SERVICE BULLETIN

#0020 Revision 2

SUBJECT: Eyebolt inspection and conditional replacement

MODELS AFFECTED: All Sling aircraft manufactured before the effective date (07/09/2022)

Figure 28: Eyebolt assembly, Detail F

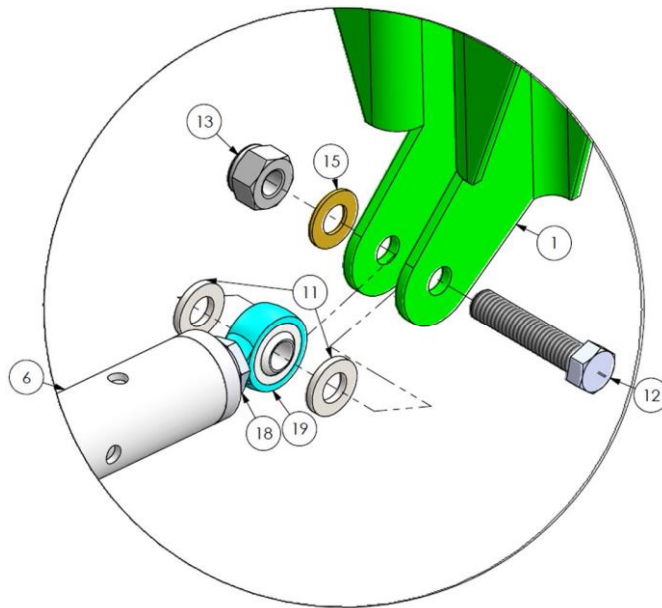
- Step 10. Once the eyebolt has been replaced, reassemble the eyebolt assembly. Refer to Figure 27 for component positions.
- Step 11. To replace the eyebolt seen in Figure 28, remove the AN4 locknut (13) and bolt (12). Replace the *noncompliant* eyebolt with either a *type 1* or *type 2* eyebolt.

- Step 12. Once the eyebolt has been replaced, reconstruct the eyebolt assembly. Refer to Figure 28 for component layout.
- Step 13. The last eyebolt that needs to be inspected and replaced is the one connected to the elevator horn, located in detail G of Figure 29.

Figure 31: Detail G, exploded view

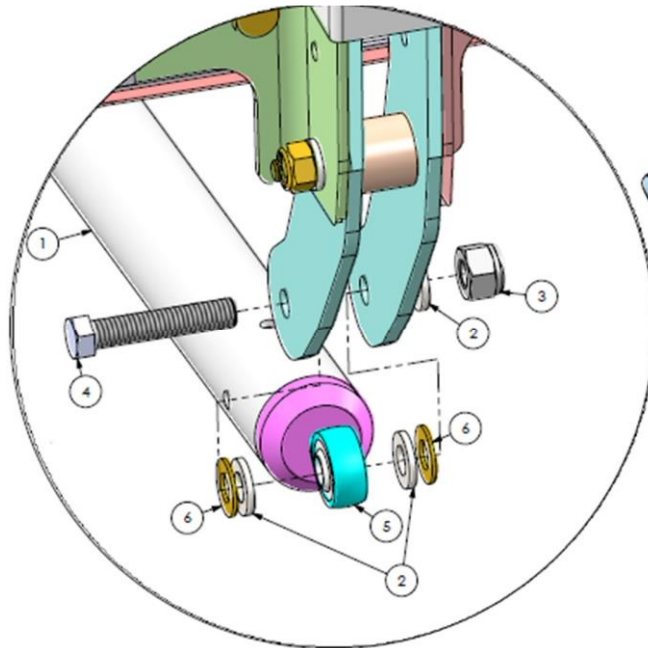
Step 15. Remove the AN4 locknut (3) and bolt (4), shown in Figure 31.

Step 16. Replace the eyebolt (5) with either a *type 1* or *type 2*.
